ABBOTT ADD	INDEX TECHNICAL SERVICE BULLETIN
---	---

PRODUCT: COMMANDER® FPC(TM) (76)	DATE: 05-MAY-97
---	----------------------------------

SUBJECT:
Automatic Bar Code Reader Prism Lens

TSB#: 76-013

Figure 1. ABC Reader Prism lens Installation

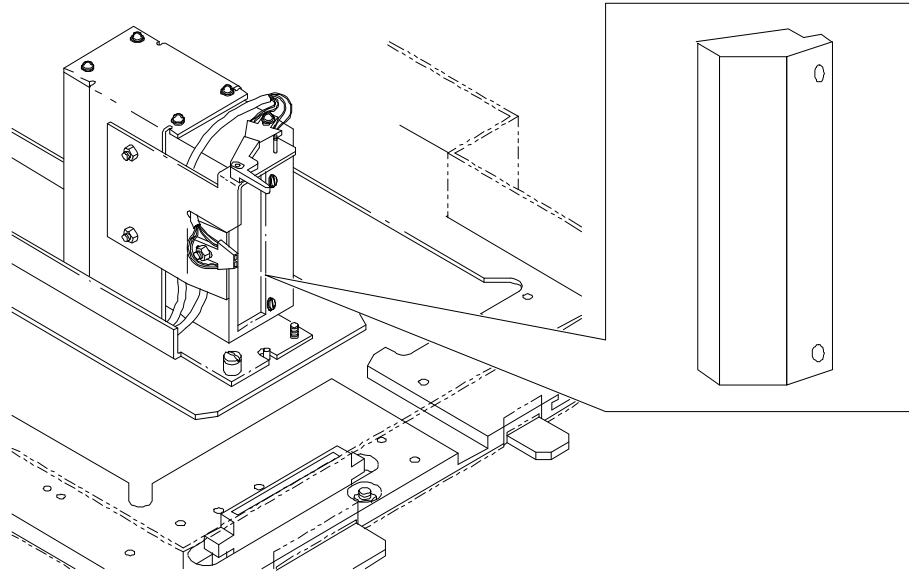
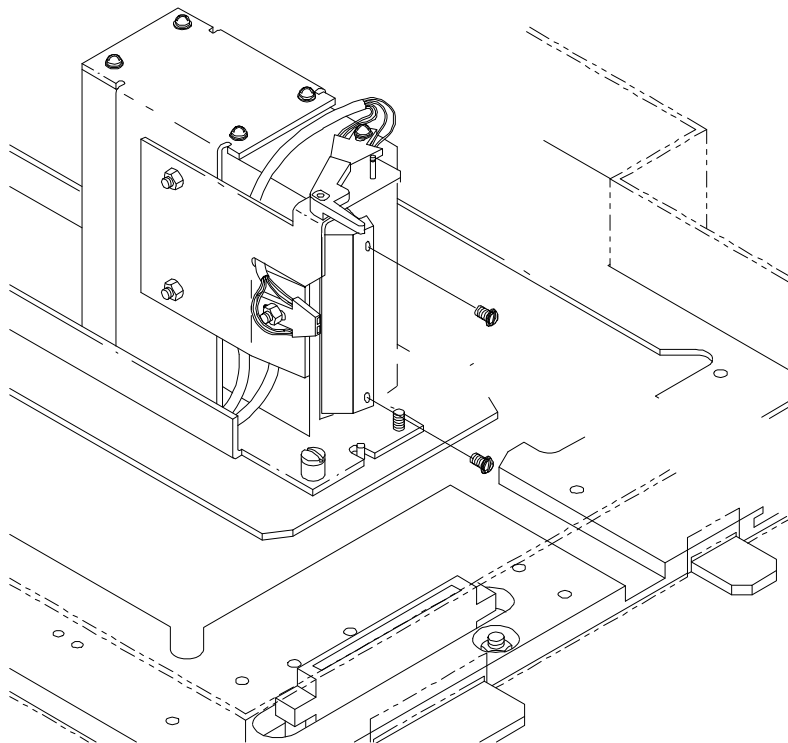
To inform the field of the addition of a prism lens to the FPC ABC (Internal Bar Code Reader) reader window. The prism lens reduces the likelihood of bar code no-reads and misreads.

The prism lens mounts on the face of the Reader Head Assembly window and refracts the brightest portion of the reflected light at an angle away from the reader sensor. Glossy labels reflect light unevenly into the reader head and can momentarily "blind" the reader. This "blinding" produces a no read or misread condition.

1. Using a small Philips screwdriver, remove two screws that secure the reader window to the metal frame. (See **Figure 2**.)
2. Clean the window, as specified below, before installing the prism lens.
3. Place the prism lens onto the red, flat plastic window as shown in **Figure 2** and align the two screws with the holes in the frame.
4. Reinstall the screws securing the prism lens onto the reader frame.

Figure 1

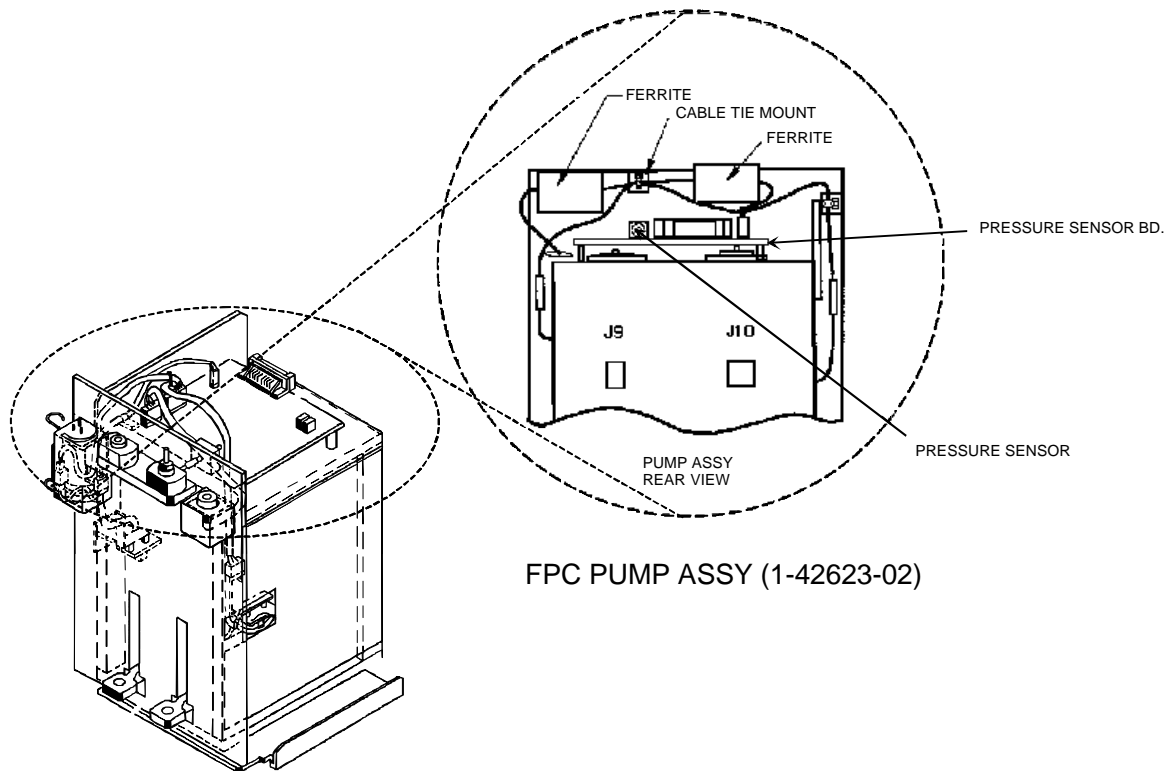
The current FPC CE Mark configuration released by TSB 76-012, called for the addition of a single Ferrite (magnetic core) to the Tip Jam Sensor cable on the FPC Pump assembly. The revised design calls for removal/replacement of the single ferrite with two (2) larger ferrites (see figure 1), spaced evenly apart on the same cable.

- a. Remove the FPC Pump assembly using the **Pump Assembly removal and replacement** procedure, in the FPC Service Manual.
- b. Referencing **figure 1**, locate the Tip Jam Sensor cable assembly that plugs into J4 on the Pressure Sense board.

- c. Remove the existing ferrite bead attached to the tip jam sensor cable (if TSB 76-012 has been installed).
- d. Compare location of the cable tie mount, to the location shown in **figure 1**. If the location is not as shown, remove the cable tie mount using a flat blade screwdriver.

- e. Replace the cable tie mount with one supplied in the CE Mark Upgrade kit; in the location shown in **figure 1**.
- f. Clamp the two ferrites supplied in the CE Mark Upgrade kit around the Tip Jam Sensor cable, in the locations shown in **figure 1**, then secure the cable tie in place. **NOTE: Insure the ferrite enclosure snaps firmly together.**

Figure 1. Motor Driver Circuit

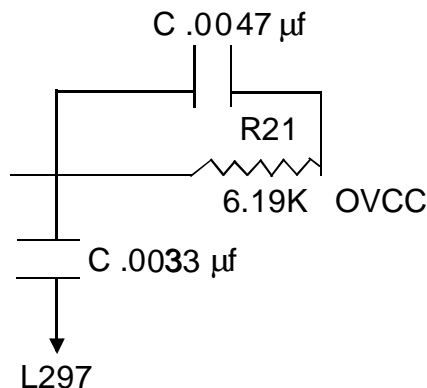
The modification specifically changes the duty cycle of the motor driver circuit. The oscillating frequency of this circuit increases from approximately 25 KHz to 33 KHz and the on-off duty cycle changes from approximately 90% on 10% off to approximately 65% on and 35% off.

The result of these two changes is a reduction of the harmonic frequencies causing the noise. See Figure 1.

- Change R21 from 15k ohm resistor, to 6.19k ohm resistor
- Change C13 from .0033 μ f capacitor to .001 μ f capacitor
- Place a .0047 μ f capacitor in parallel with R21, a 6.19K ohm resistor. See **Figure 1**.

Figure 7

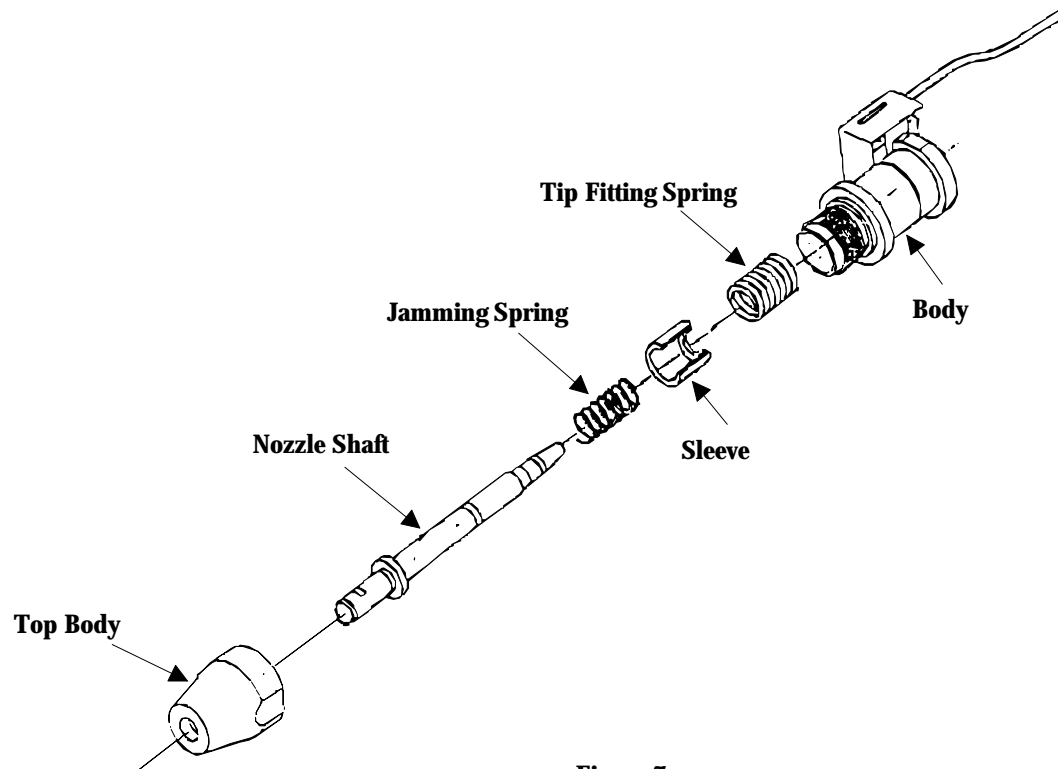
The sample nozzle shaft assembly has been altered. The alterations include one piece design and a change in shape to the tip end of the shaft. The change in shape of the shaft will decrease the surface area of the shaft that comes into contact with the tip. Decreasing the surface area increases the pressure at the contact points there by increasing the likelihood of obtaining a good tip nozzle seal.

- Replace the nozzle shaft with the new one-piece nozzle shaft.
- (refer to **figure 7**) Re-install the tip fitting spring (**heavy spring**), (**Extremely important that the jamming spring fits inside of the sleeve**) sleeve, jamming spring (light **spring**), one-piece nozzle shaft, and top body.

Figure 1: Location of EEPROM (E12) on MPU (UN101)

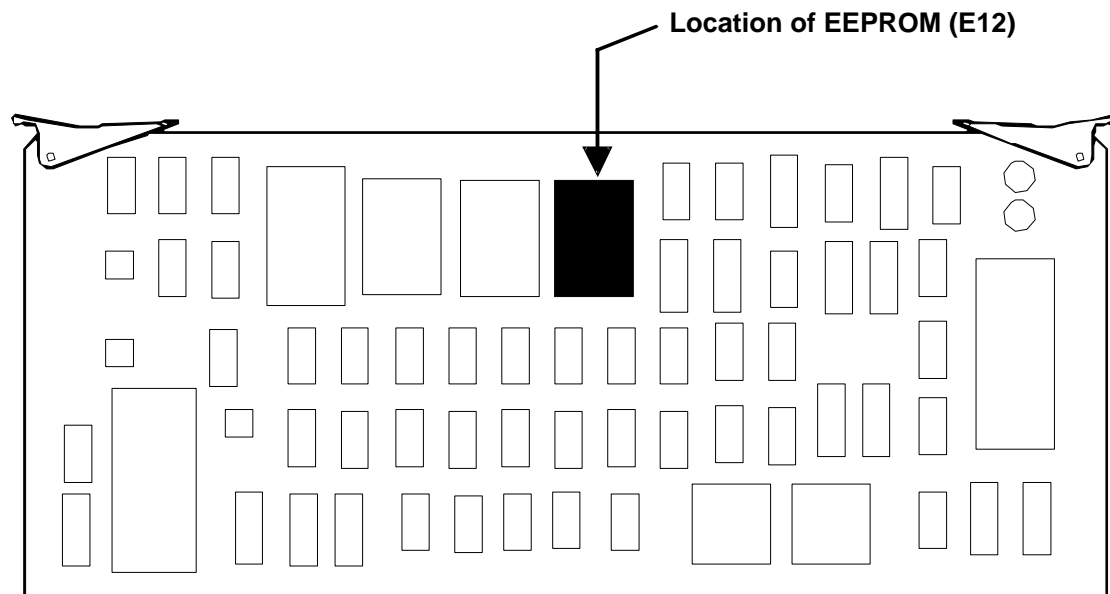
9. Remove the old EEPROM (Version 3.2, P/N 42787-103) from location E12 (see Figure 1 for location) by gently prying up on the EEPROM chip between the socket and EEPROM chip with a small flat head screw driver. Note the orientation of the chip before you remove it.

10. Take the new EEPROM (Version 3.3, P/N 42787-104) from TSB Kit and replace it in the socket that you just removed the old EEPROM from. When inserting the new EEPROM be sure to orient it the same as the old EEPROM (If you did not note the orientation in the previous step, look at the chip E13 for proper orientation).

Figure 1: TSB Sticker Location

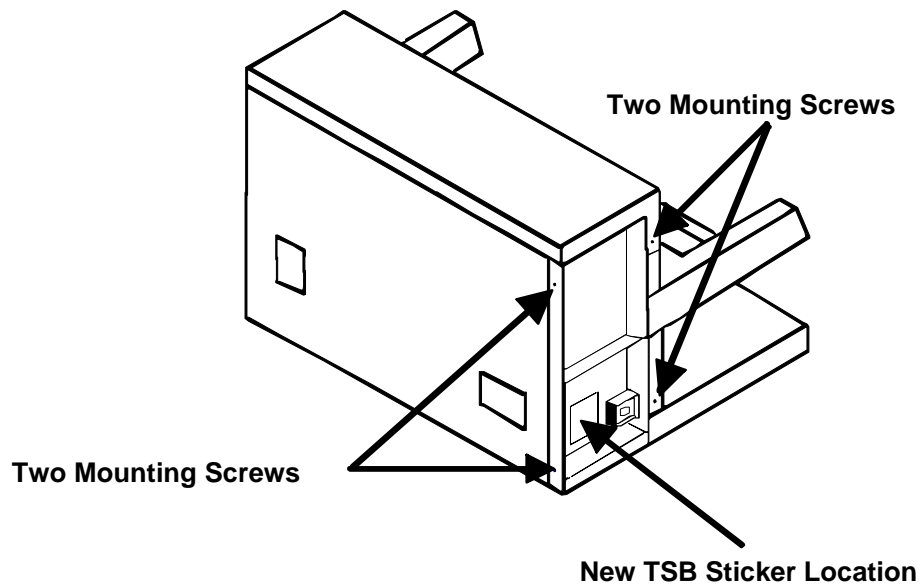
To change the location of the TSB Sticker (Refer to Figure 1 for new location).

1. Turn off power to the FPC.
2. Disconnect the A.C. Power Cord, F-Link Power Cable, RS-232 Conversion Cable from the back of the Pipettor.
3. Remove the Left Side Cover of the FPC, (see **Figure 1**) by removing the four mounting screws.
4. Mark out the number 1 on the TSB sticker to show that TSB 001 is completed. (Be sure to transfer all information from the old TSB Sticker to the new sticker.)
5. Place the TSB Sticker on the inside of the Left Side Frame (see **Figure 1**), approximately one inch from the bottom and one inch from the Power Switch Bracket.
6. Reassemble the instrument using steps 3 through 1 in reverse.
